11 Pomeroy Street

Single Family and Street Construction

RE: Level I-Minor Residential Development Review Site Plan Revisions
Level II-Preliminary & Final Site Plan Development Revisions
Chabad Lubavitch of Maine LLC.
Pomeroy Street

TO: Nell Donaldson, Planner
FROM: David Senus, P.E.
DATE: May 3, 2013
RE: Pomeroy Street Construction, Level II Site Plan Application

SHEET
1
 REPRODUCTION OR REUSE OF THIS DOCUMENT WITHOUT THE EXPRESSED WRITTEN CONSENT OF BH2M INC. IS PROHIBITED

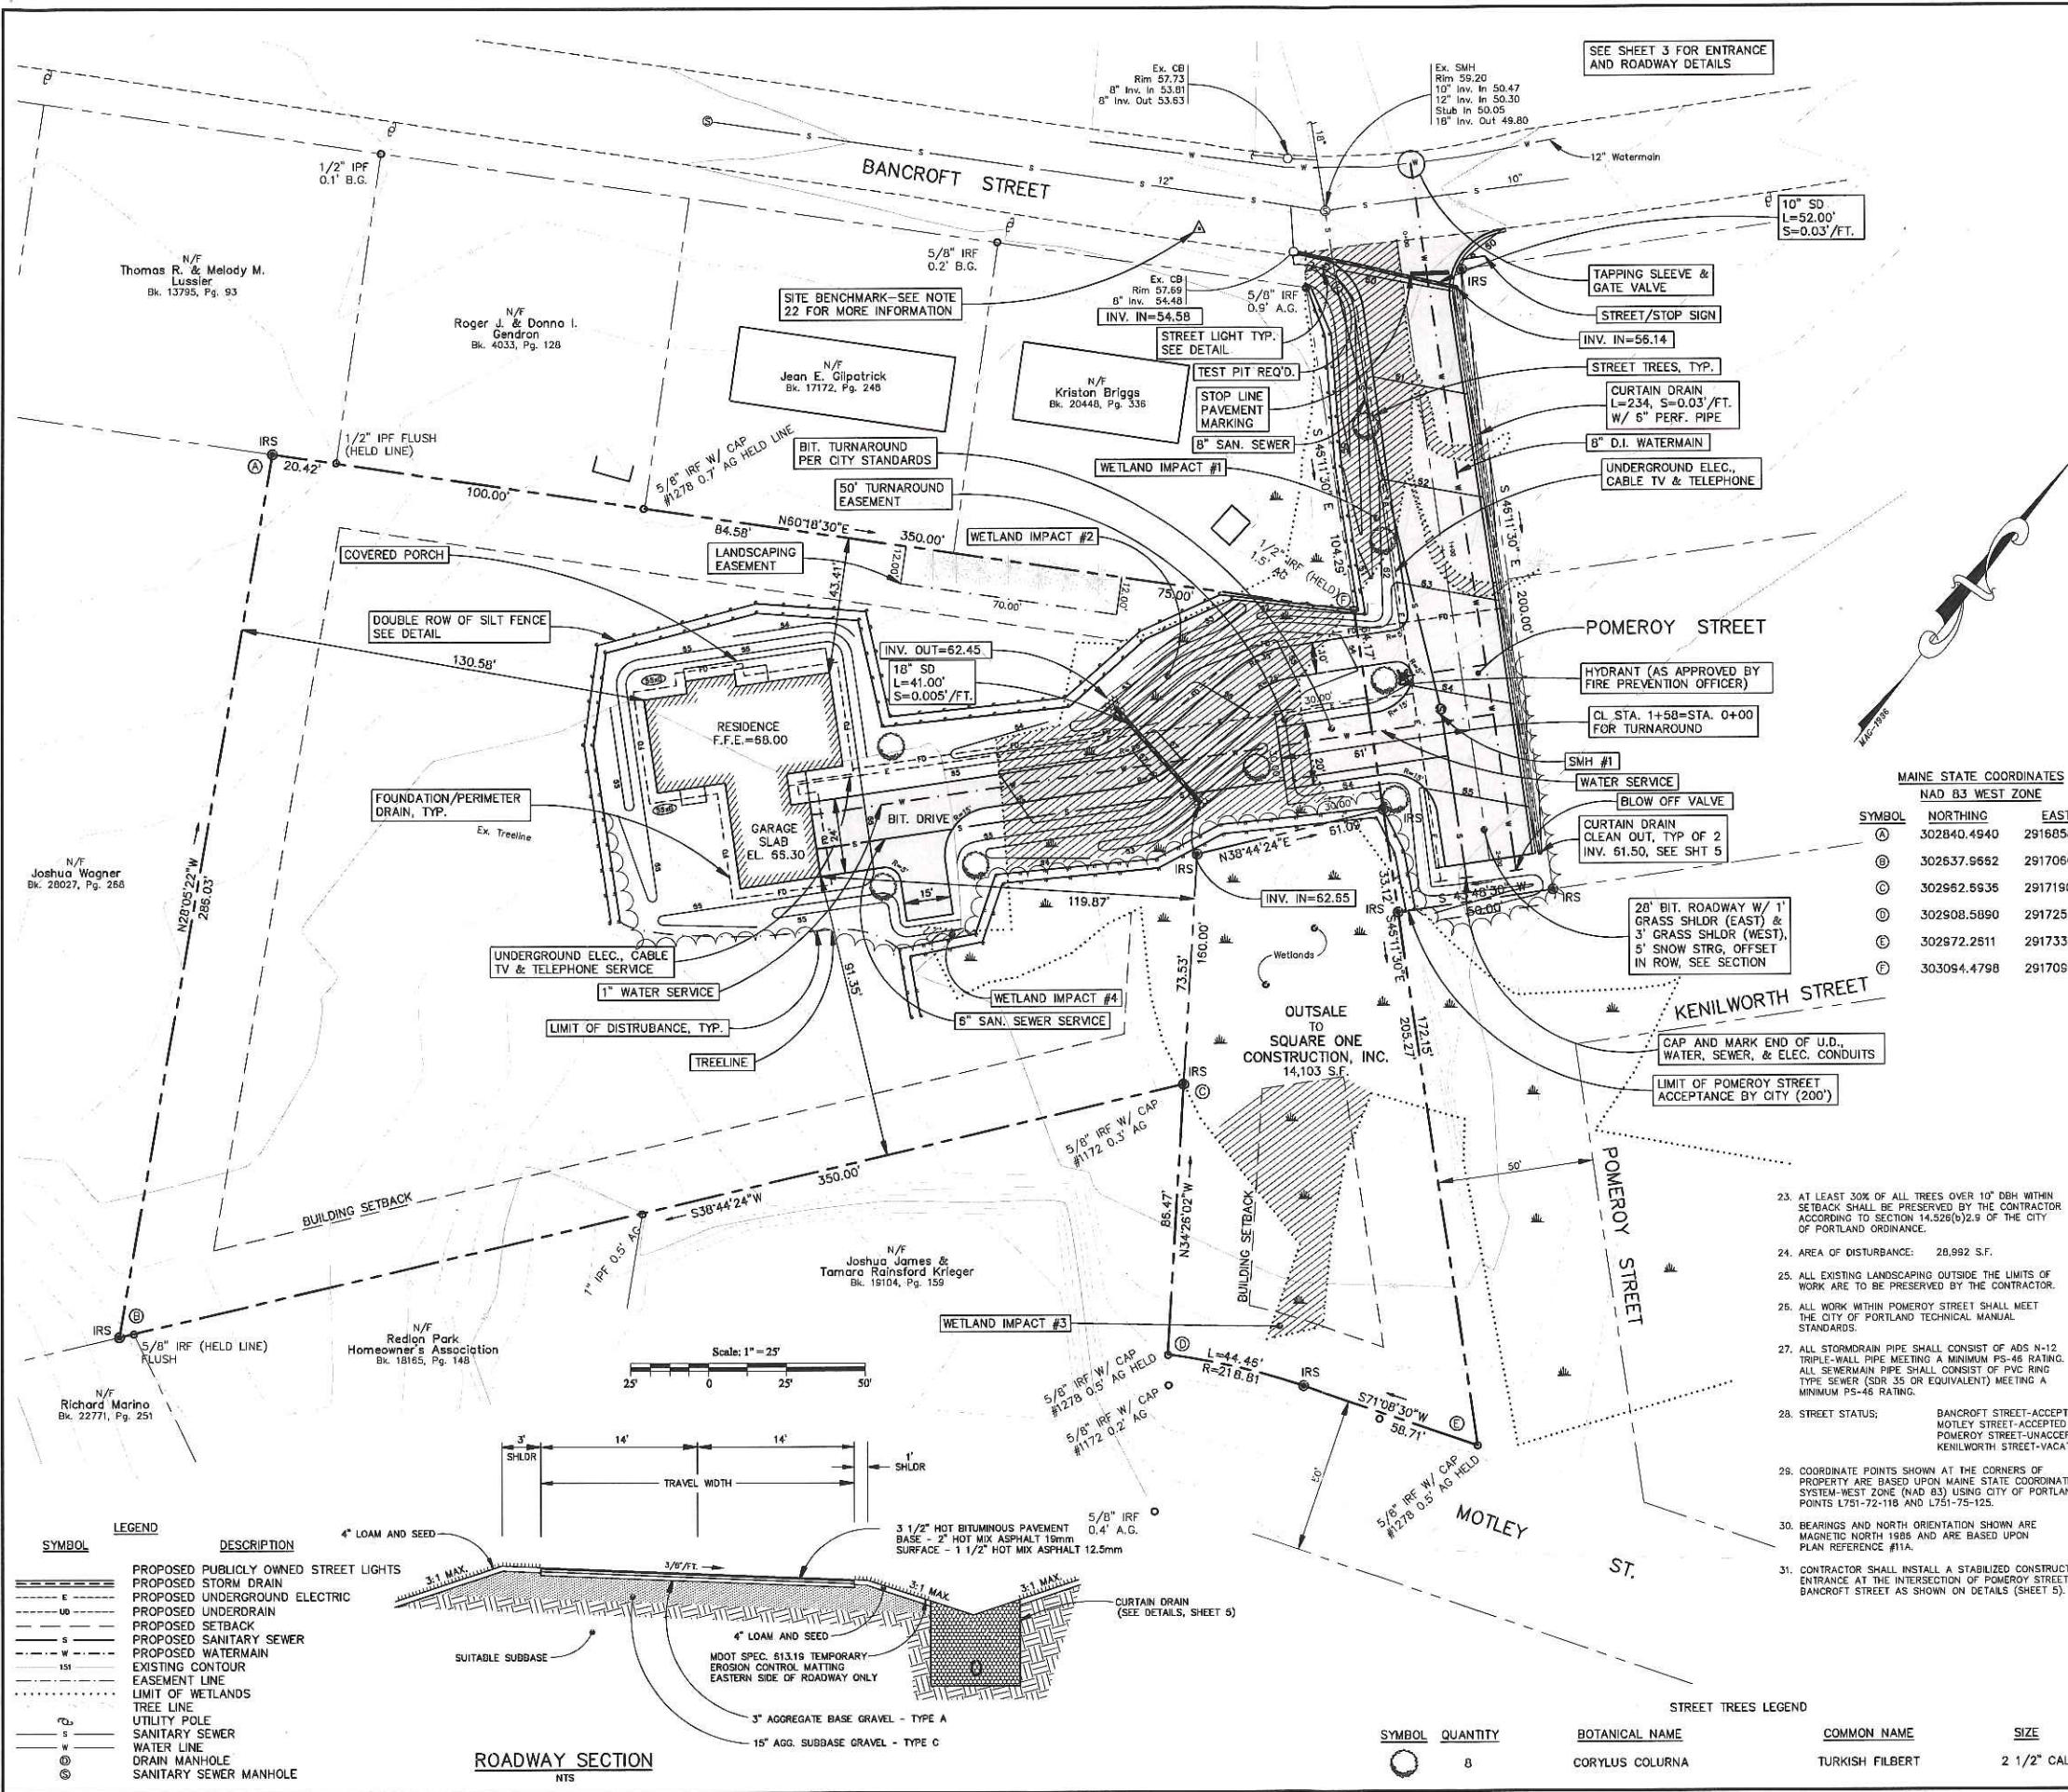
Comments from Nell Donaldson, City Planner, dated May 15, 2013 for street extension:

1. The plans have been revised (see sheet 1 of plans) to include a turnaround with a depth of 30 feet as required by the City Technical Manual, Section I-3 and Schematic I-5.

8. A 1-foot wide grassed shoulder has been added along the Eastern side of the proposed Pomeroy Street (see sheet 1 of plans).
9. A temporary erosion control mat has been added along the inslope of the Eastern side of Pomeroy Street above the curtain drain per Maine DOT Specifications (see sheet 1 of plans).
10. Curtain drain clean outs have been added to the storm drain system as requested (see sheet 1 of plans). A detail of this cleanout was also added to sheet 5 of the plans.
11. The pipe crossing Pomeroy Street from the end of the curtain drain to the existing catch basin in Bancroft Street has been specified on the plans to be a 10-inch diameter stormdrain (see sheet 1 of plans).

1. The site benchmark is described in note # 22 on sheet 1 of the plans. The description and history of the site benchmark was addressed in our previous response letter to the City dated November 12, 2012 (additional comments #2).

1. The driveway to the proposed residence has been reduced in size to 10-feet in width as requested (see sheet 1 of plans).

- Note #33 regarding cut off lights was added to sheet 1 of the plans as requested.
- Landscape buffering was added on the northern side of the proposed building as requested (see note #32 on sheet 1 of the plans for more information).
- Addressing David Senus of Woodard and Curran Comments:
 - The curtain drain detail on sheet 5 of the plans has been revised as requested.
 - A note was also added to this detail regarding the filter fabric to assure no clogging will occur.
 - A gravel transition layer has been added to the curtain drain detail as requested (see sheet 5).
 - A catch basin was added at approximate station 0+15 along Pomeroy Street as requested (See sheet 1 of plans).

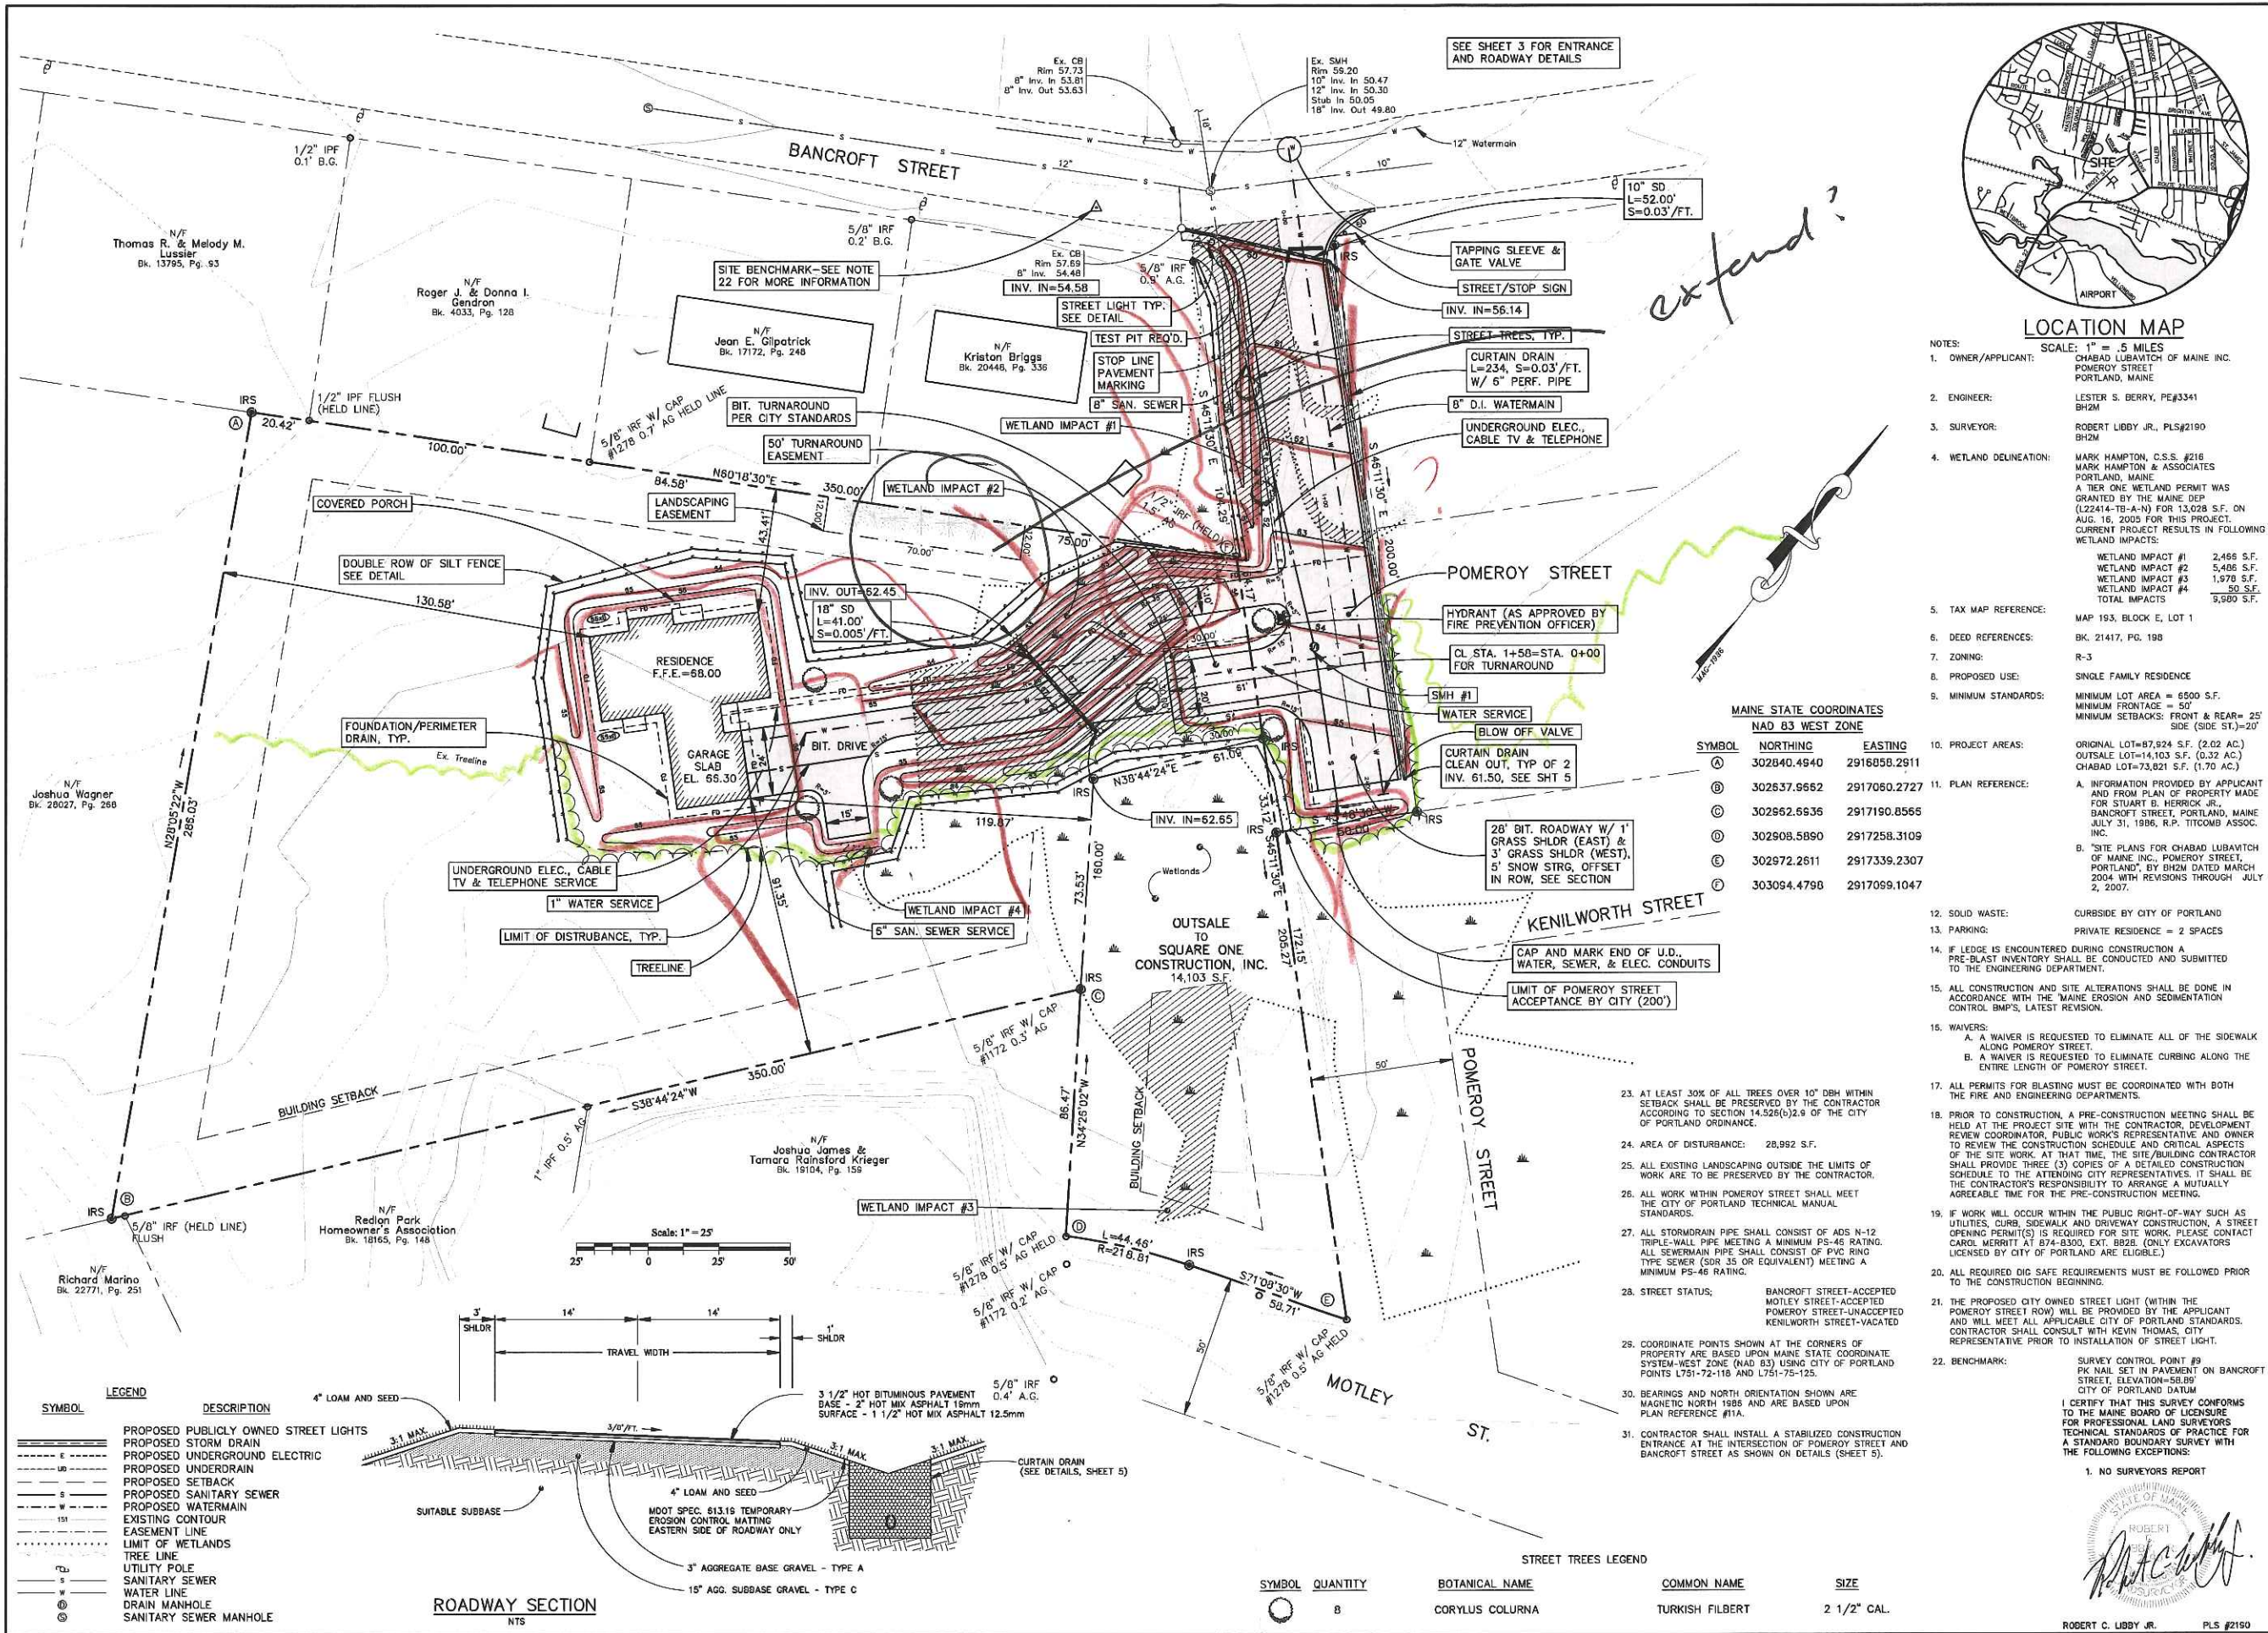
- Please add a note to plans that all work within the proposed Pomeroy Street right-of-way shall meet *City of Portland Technical Manual* standards.
- On Sheet 1 please indicate the status of the streets shown (i.e. accepted, vacated, paper, etc). In addition, please show Kenilworth Street. A separate survey plan for acceptance is suggested. **KENILWORTH IS VACATED. UPDATED NOTE.**

- Please indicate the total right-of-way width and distances to property lines on Sheet 1.
- Sheet 1 should be on the Maine State Plane for acceptance.
- Sanitary manhole rims are not acceptable as an official city benchmark. **The site bench mark is now on a PK in Bancroft St. What City of Portland benchmark was used to set this benchmark (Note 22)?**

3. Please add note to plans that all work within the proposed Pomeroy Street right of way shall meet City of Portland Technical Manual standards.
Note 26 Sheet 1 now states this.
